VEHICLE RECALL

G - 05505
April 2005

SUBJECT: SAFETY RECALL (U.S., EXPORT)
Engine cover lid on certain FE School Bus and FE
Commercial Bus models built between 09-04-2003 and
02-05-2005

Figure 4

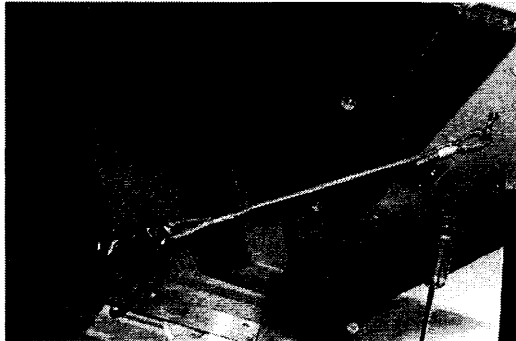
5. To retain the engine access cover in the open position, remove the cable latch from the right latch bracket and snap it on to the eye of the engine access cover latch bracket. See Figure 4.
